Access Compliance Report Public Rights-of-Way (Curb Ramps)

Main Street: ADAMS_ST Cross Street: MIDWAY_PL Location: S

ADA ID: RPRK210929160059 Ramp Type: Type 1 - Perpendicular Diagonal Initial Pass/Fail: Fail Overall Compliance: No Severity Score: 2

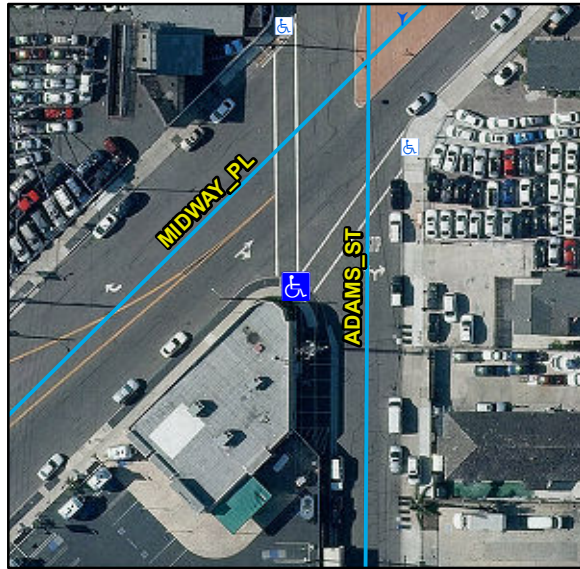
R304.2.2, R304.5.3, STD 1115

Remove & Replace Curb Ramp With Two New Directional Ramps or Equivalent.
